PENNY LAKES SUBDIVISION

APPLICATION NUMBER 13 DATE September 7, 2017

APPLICANT Penny Lakes Subdivision

REQUEST Subdivision

DETAIL SITE PLAN

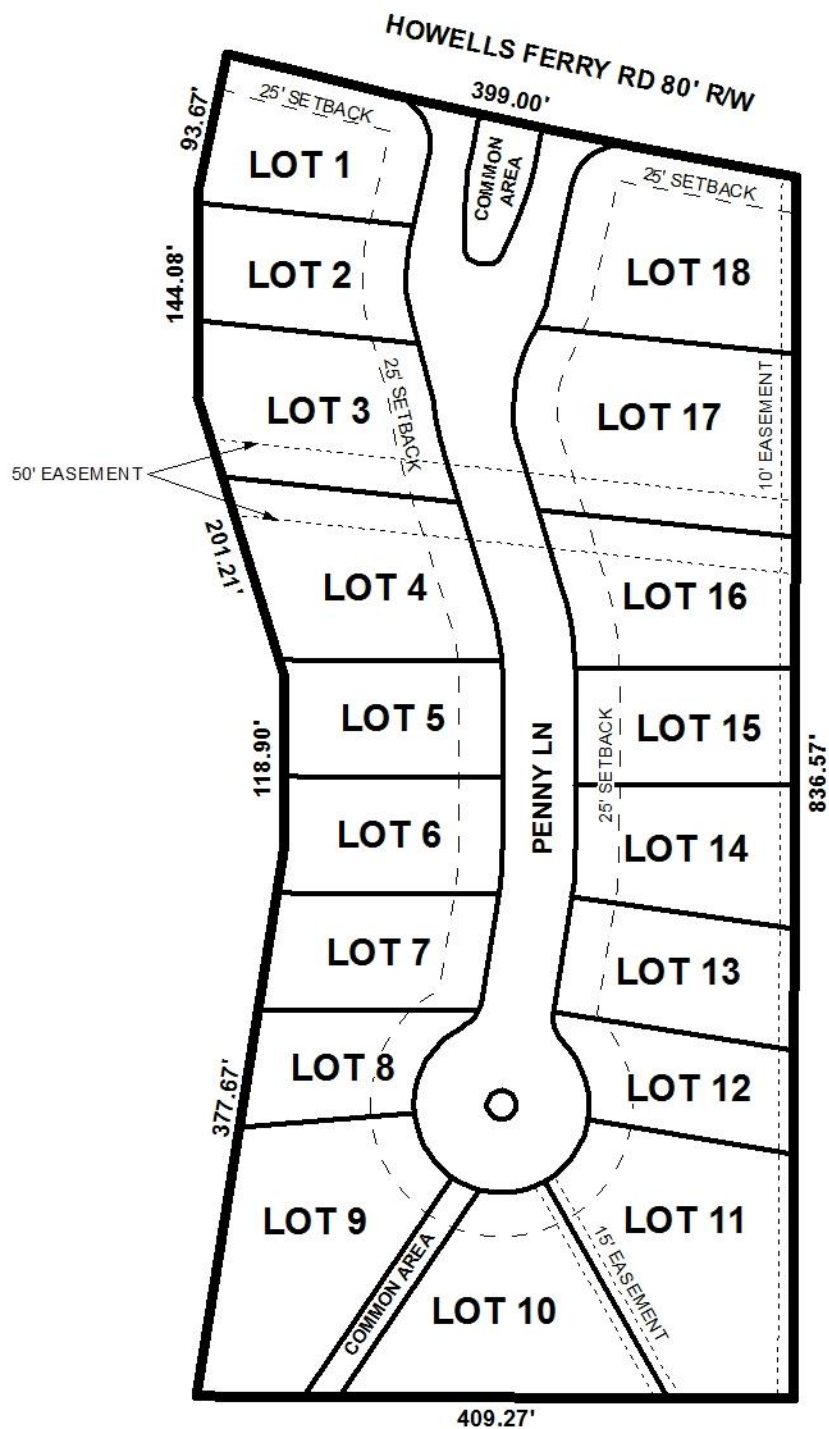
The preliminary plat illustrates the proposed 18-lot, 7.7± acre subdivision which is located on the South terminus of Eunice Drive. The site is within the Planning Jurisdiction and the applicant states that the subdivision is served by public water and sewer. The purpose of this application is to create eighteen (18) legal lots of record from a portion of two (2) metes and bounds parcels.

The preliminary plat depicts "Parcel 'A' Future development" on the remainder of the southern-most metes-and-bounds parcel.

The proposed lots front Howells Ferry Road, a minor arterial on the Major Street Plan. The right-of-way width for Howells Ferry Road is depicted as 80' on the preliminary plat and therefore no dedication is required. The proposed lots also front a proposed new road, Penny Lane, which is illustrated on the preliminary plat. The right-of-way width for the proposed Penny Lane has not been provided. If approved, the right-of-way width to Penny Lane should be depicted on the Final Plan to provide at least 50' which is sufficient for a minor street with curb and gutter. The proposed street is a closed end, cul-de-sac with a right-of-way diameter of 120'. If approved, the diameter of the cul-de-sac should be retained on the Final Plat.

In accordance with Section V.D.2. of the Subdivision Regulations, the proposed lots exceed the 7,200 square foot minimum lot size requirement for lots served by public water and sanitary sewer systems. The lot size information is depicted in both square feet and in acres on the preliminary plat and should be retained on the Final Plat, if approved.

The preliminary plat illustrates a 25' minimum building setback for Lots 1 and 18 along Howells Ferry Road. If approved, the setbacks should be retained on the Final Plat. Lots 2-17 front the proposed Penny Lane and illustrate 30' minimum building setback that, if approved, should be retained on the Final Plat.

There is a 50' MAWSS waterline easement, 15' drainage easement, and a 10' drainage and utilities easement located within the subject site. A note should be placed on the Final plat stating that no structure shall be erected in any easement.

As a means of access management, a note should be placed on the Final Plat, if approved, stating that each lot is limited to one curb cut to Penny Lane, and denied direct access to Howells Ferry Road, with the size, design and location of the curb-cut to be approved by Mobile County Engineering and conform to AASHTO standards.

Common areas are depicted on the preliminary plat. A note should be placed on the Final Plat stating that maintenance of the common areas shall be the responsibility of the property owners, and not Mobile County.

- 1) Retention of 80' right-of-way width to Howells Ferry Road;
- 2) Retention of the 25' minimum setback line along Howells Ferry Road, adjusted for dedication;

- 3) Retention of the lot size information in both square and in acres on the Final Plat;
- 4) Provision of a minimum of a 50' right-of-way width along the proposed Perry Lane;

- 5) Retention of 30' minimum setback line along the proposed Perry Lane;
- 6) Placement of a note stating that no structures shall be erected in any easement;

- 7) Placement of a note on the Final Plat stating each lot is limited to one curb cut to Penny Lane, and denied direct access to Howells Ferry Road, with the size, design and location of the curb-cut to be approved by Mobile County Engineering and conform to AASHTO standards;

11) Placement of a not stating that maintenance of the common areas shall be the responsibility of the property owners, and not Mobile County.
